Agenda
Village of Arlington Heights
Design Commission
Community Room, 3rd Floor

Arlington Heights Village Hall
33 S. Arlington Heights Road
Arlington Heights, IL 60005
September 20, 2016
6:30 PM

**MINUTES OF
THE VILLAGE OF ARLINGTON HEIGHTS
DESIGN COMMISSION MEETING
HELD AT THE ARLINGTON HEIGHTS MUNICIPAL BUILDING
33 S. ARLINGTON HEIGHTS RD.
AUGUST 23, 2016**

PROPOSED WEST ELEVATION
1/4" = 1'-0"

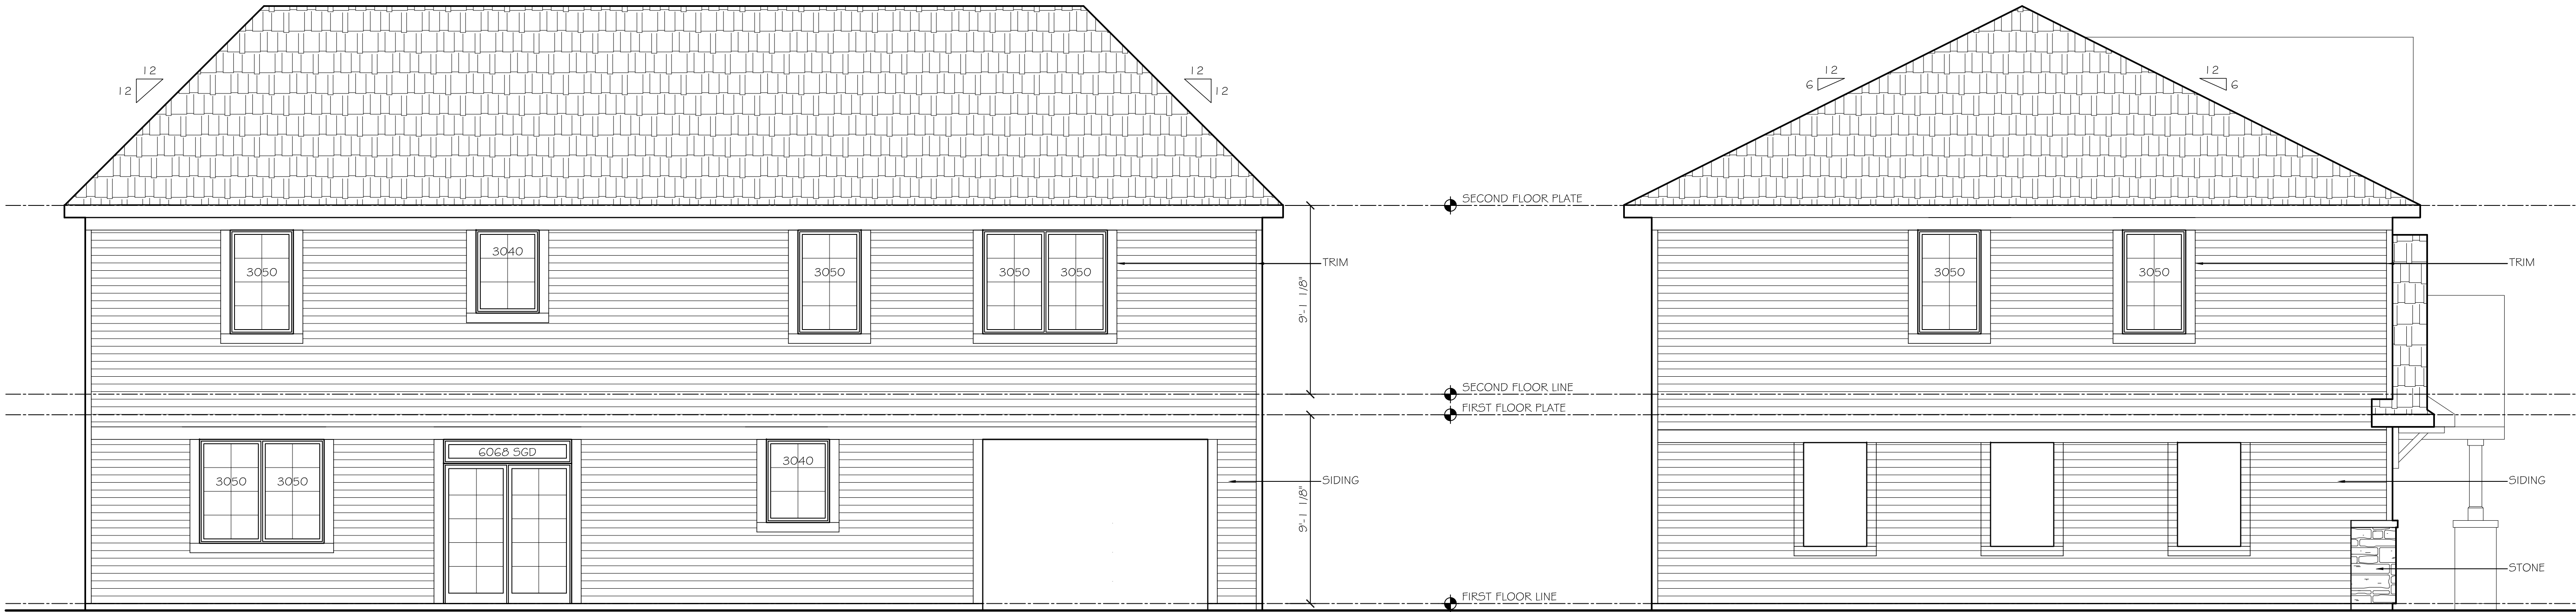
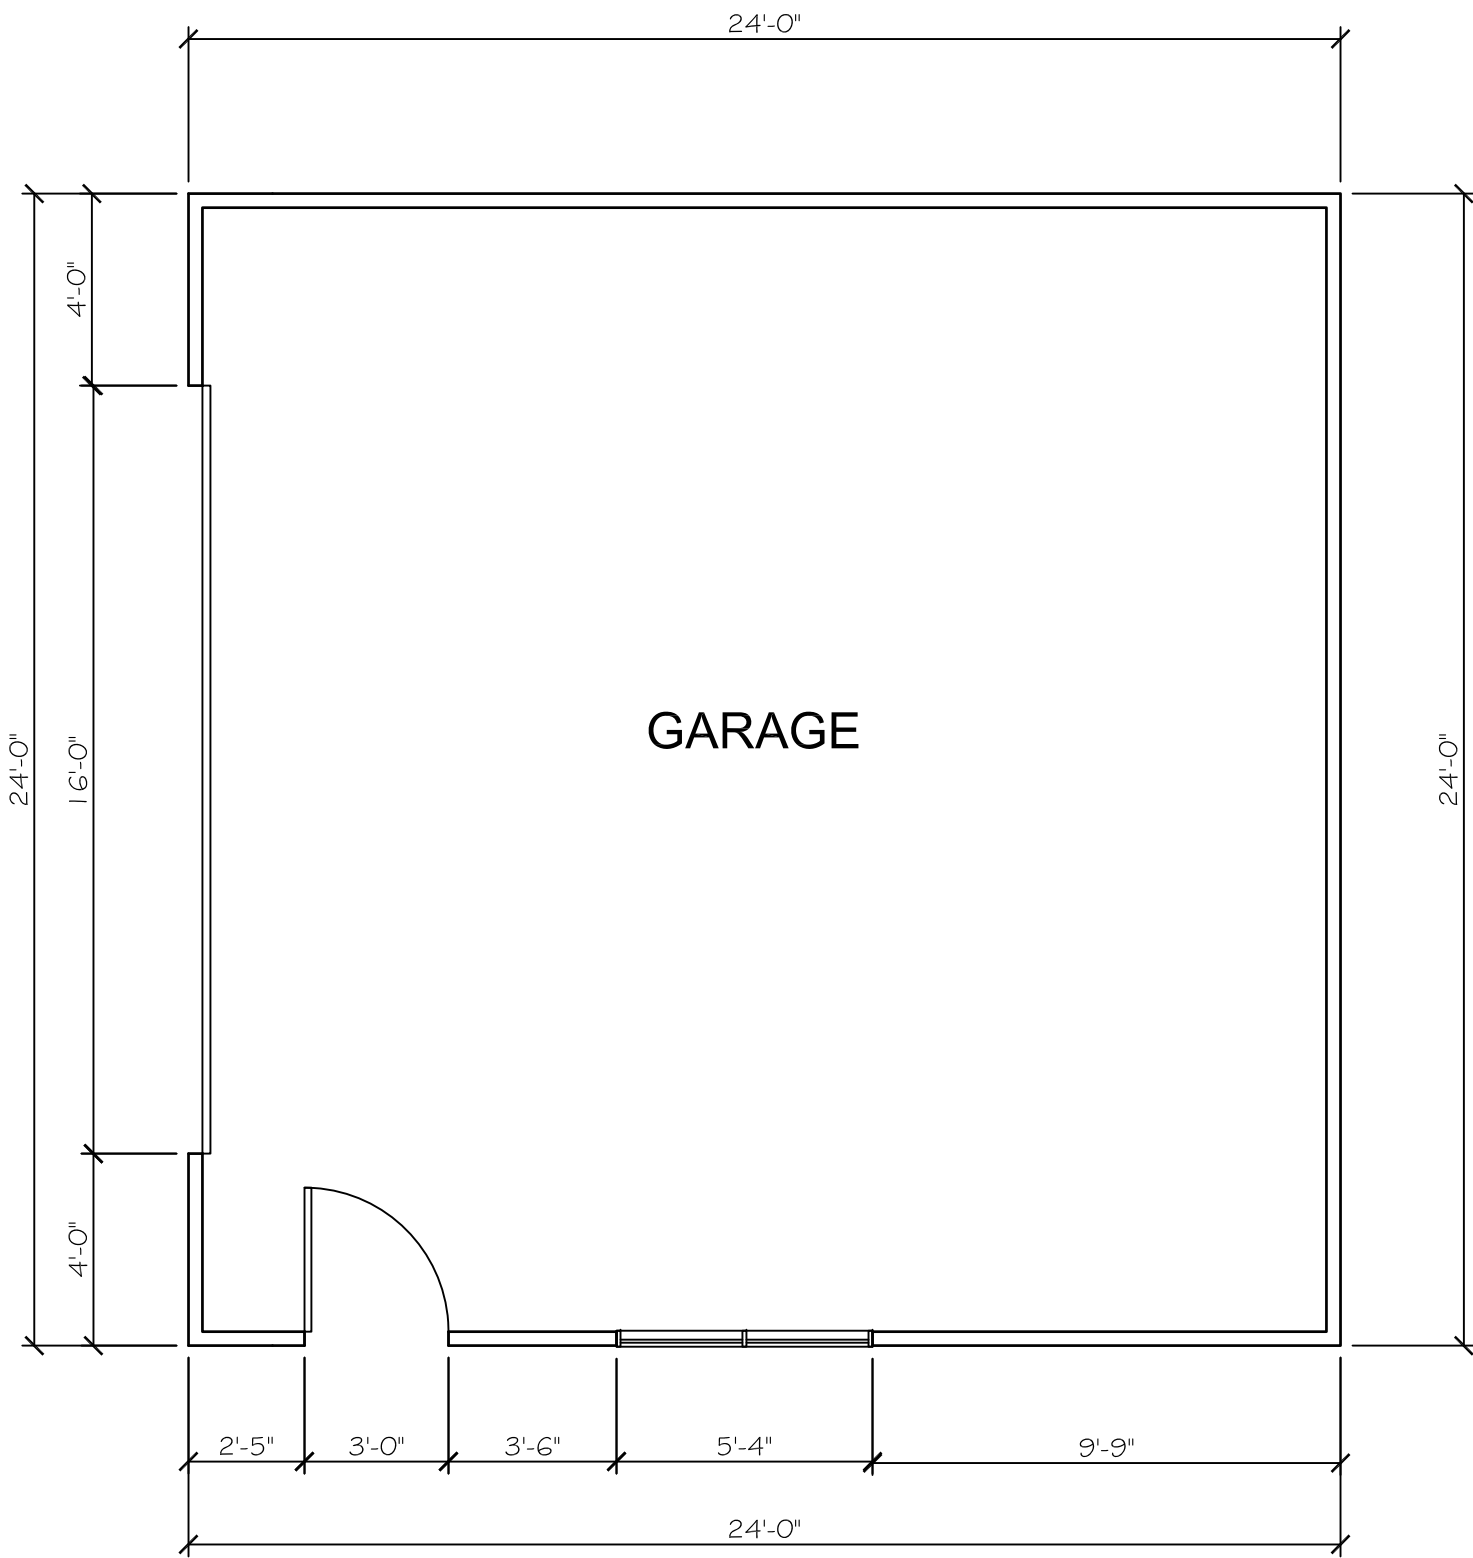
Overall, the proposed addition is nicely designed. The front elevation has a well organized and balanced composition. The front porch roof helps the house to relate to the scale of the adjacent single story homes, and the hipped main roof helps to keep the height of the side walls from being too tall. The only suggestion would be to add a portico over the rear patio door to break up the large flat wall. The portico should be detailed similar to the front entry porch.

1. A recommendation to add a portico over the rear patio door with details similar to the front elevation.

PROPOSED ELEVATION $1/8" = 1'-0"$

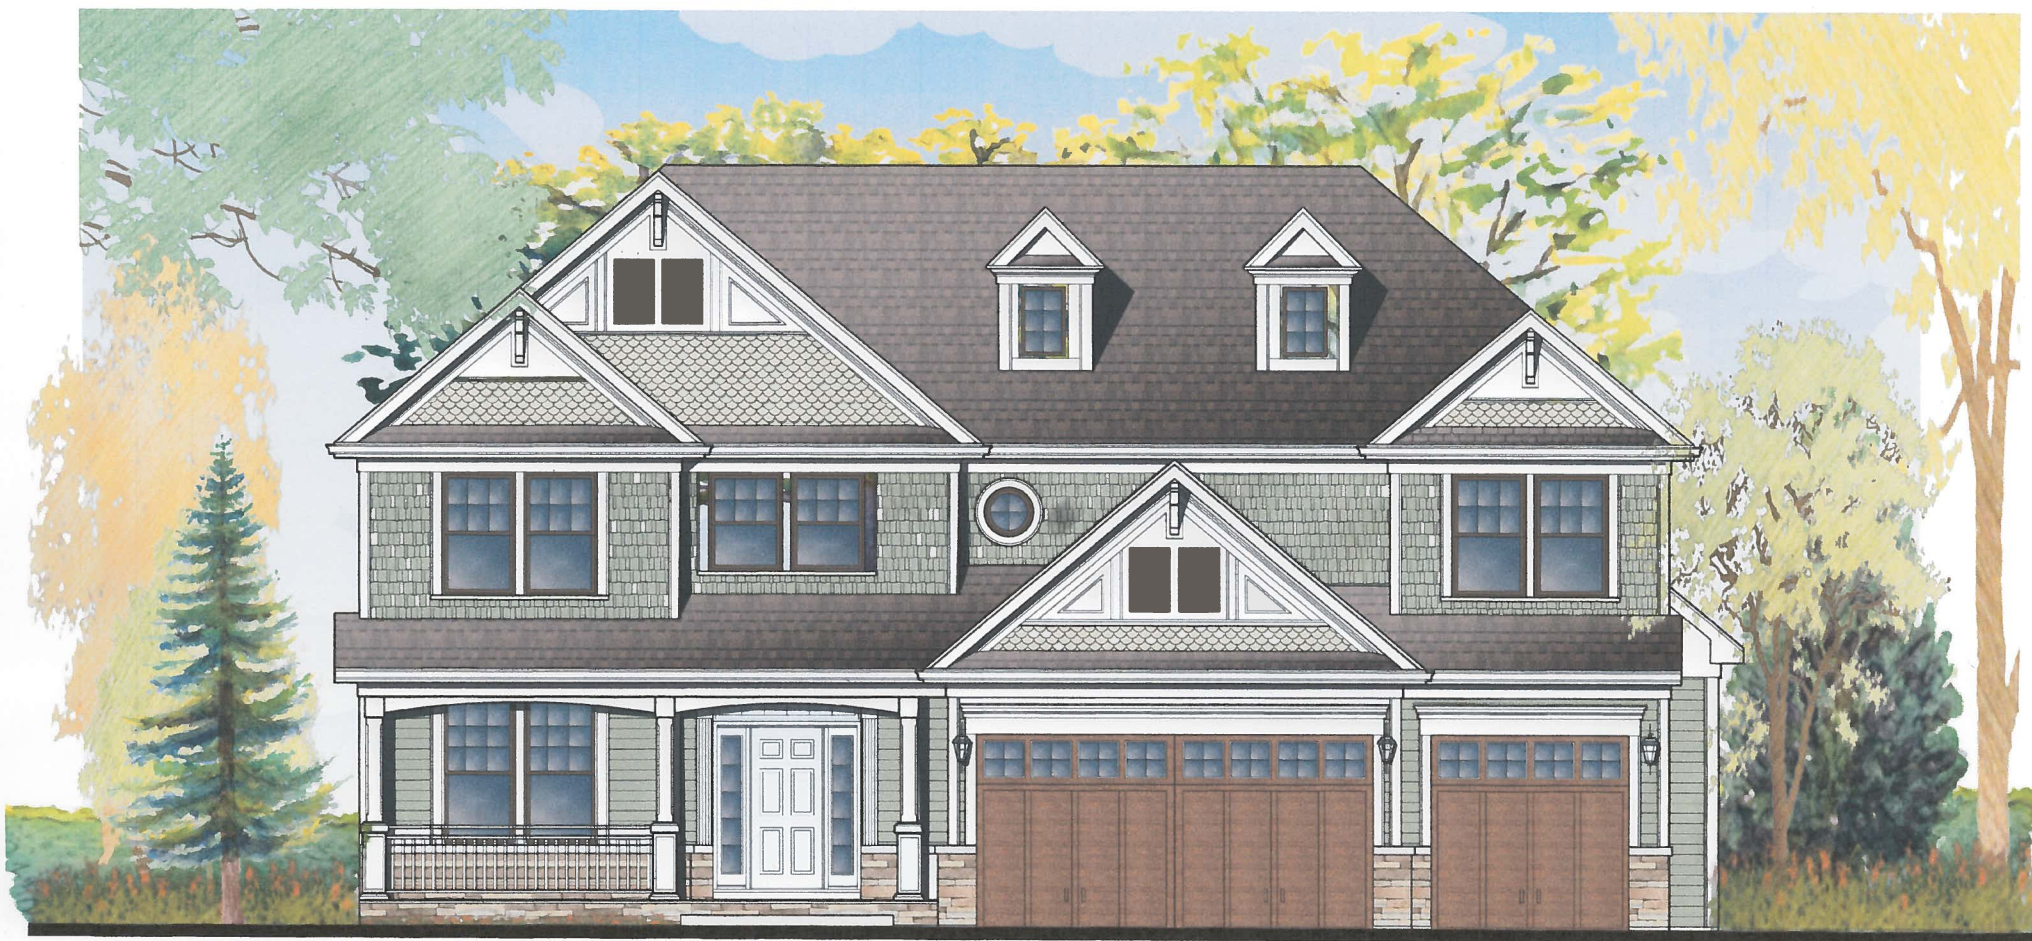
1. The two dormers on the roof are a nice detail, but they add to the visual height and size of the home. Omitting the dormers should be considered.
2. The right elevation is highly visible, so it is recommended that the stone base be continued down the side to the door.
3. A window should be added to the side of the garage to break up the wall.
4. Two windows should be added to the second floor to break up the blank wall.

1. Consider omitting the two roof dormers.
2. Continue the stone base down the right side to the door.
3. Add a window on the side of the garage.
4. Add two windows on the second floor of the right side elevation.
